PRODUCT/PROCESS CHANGE NOTICE (PCN)

PCN #: TB1403-01	DATE April 9, 2014	MEANS OF DISTINGUISHING CHANGED DEVICES:
Product Affected: TSSOP-14, TSSOP-16	shipped in Tape & Reel	☐ Product Mark
(Refer to Attachment II for affected part#)		☐ Back Mark
Date Effective: July 9, 2014		☐ Date Code
		☒ Other

ATTACHMENT I - PCN #: TB1403-01

Detail of Change: This notification is to advise our customers that IDT has planned to standardize the following items on TSSOP-14 and TSSOP-16 to only one type as detailed below.

Figure1: Illustration of Carrier Tape Pocket Dimensions

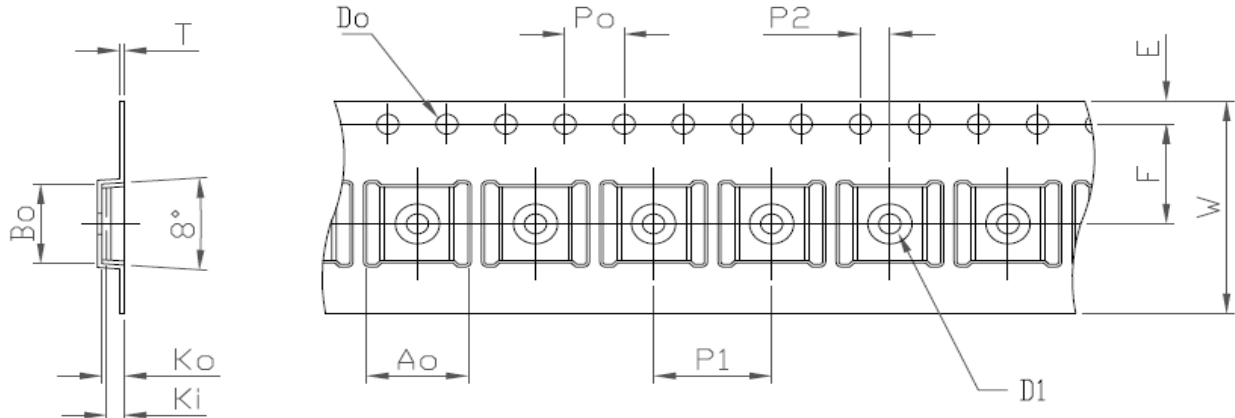
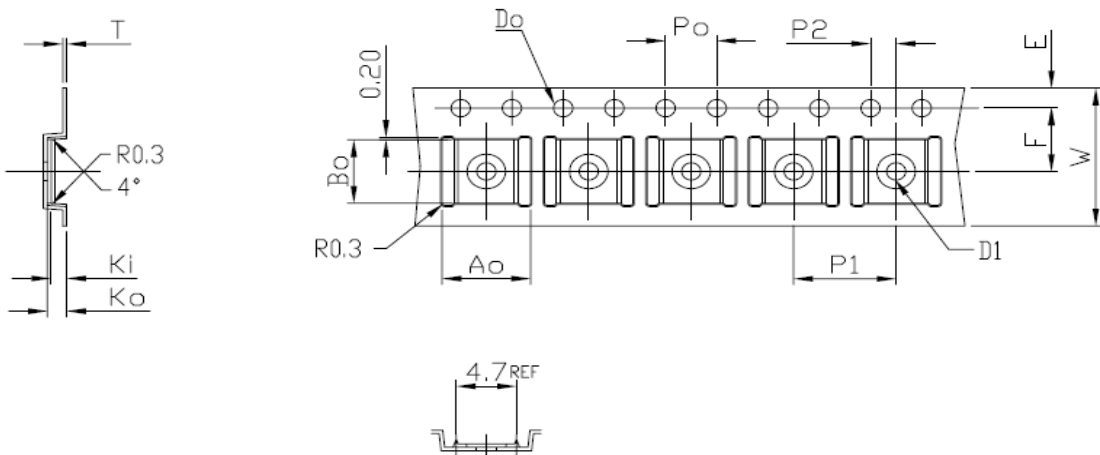
From: Carrier Tape (P8-195-P16) - Pocket Dimensions

$A_o \pm 0.1$	$B_o \pm 0.1$	$K_o \pm 0.1$	$K_i \pm 0.1$	$E \pm 0.1$	$F \pm 0.1$	$P_o \pm 0.1$	$P_1 \pm 0.1$	$P_2 \pm 0.1$	$D_o \pm 0.1$	$D_1 \pm 0.1$	$T \pm 0.05$	$W \pm 0.1$
6.8	5.4	1.7	1.3	1.75	7.5	4.0	8.0	2.0	$\phi 1.5$	$\phi 1.5$	0.30	16.0

To: Carrier Tape (P8-290-P16) - Pocket Dimensions

$A_o \pm 0.1$	$B_o \pm 0.1$	$K_o \pm 0.1$	$K_i \pm 0.1$	$E \pm 0.10$	$F \pm 0.05$	$P_o \pm 0.1$	$P_1 \pm 0.1$	$P_2 \pm 0.05$	$D_o \pm 0.1$	$D_1 \pm 0.1$	$T \pm 0.05$	$W \pm 0.1$
6.9	5.4	1.5	1.2	1.75	5.5	4.0	8.0	2.0	$\phi 1.5$	$\phi 1.5$	0.3	12.0

Figure2: Illustration of Carrier Tape Pocket Design

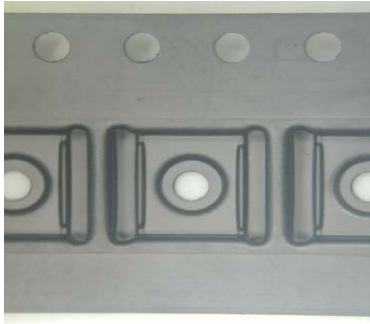
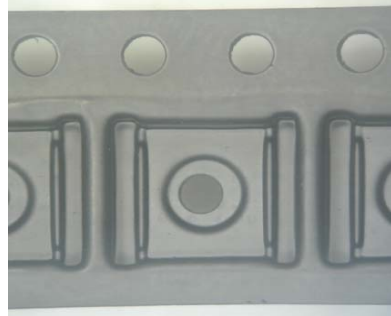
From: Carrier Tape (P8-195-P16)

To: Carrier Tape (P8-290-P16)

Figure3: Illustration of Plastic Reel

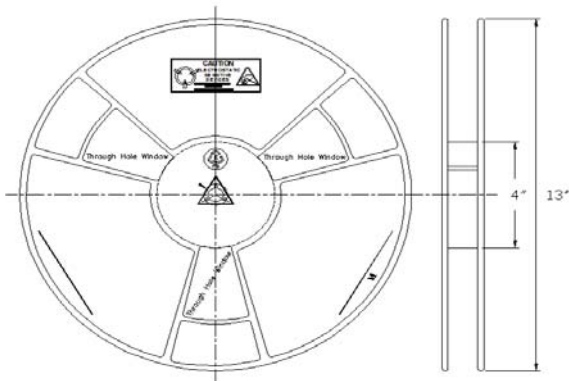
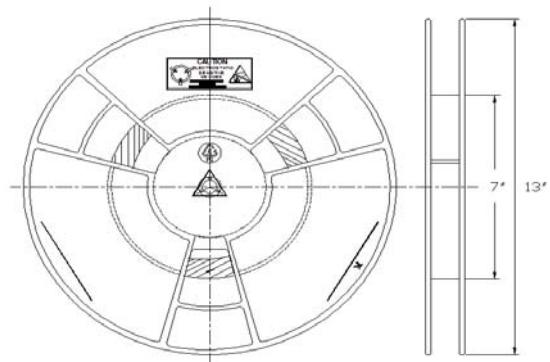
From: 13"/4" Hub Plastic Reel

To: 13"/7" Hub Plastic Reel
